B. U. T.
SERVICE BULLETINS

BRITISH RAILWAYS

SERVICE BULLETIN

Before Alteration

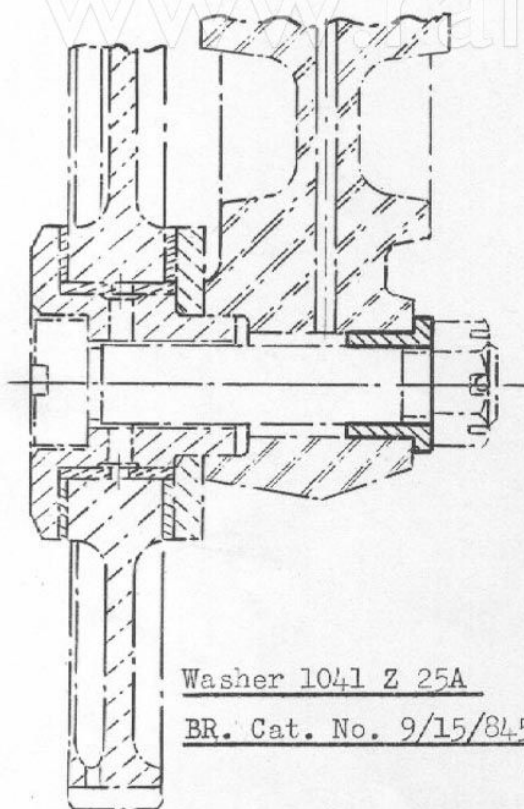
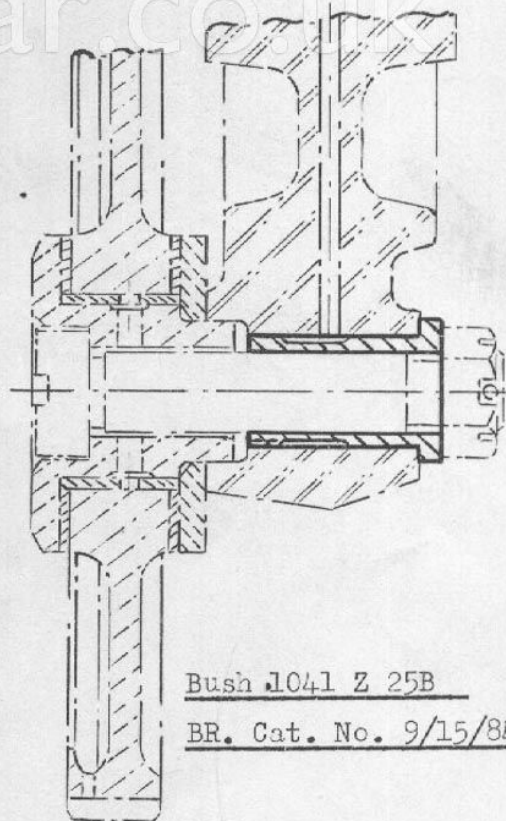
This bush supersedes the washer shown on Bulletin No. 86 and must be fitted when replacements are required.
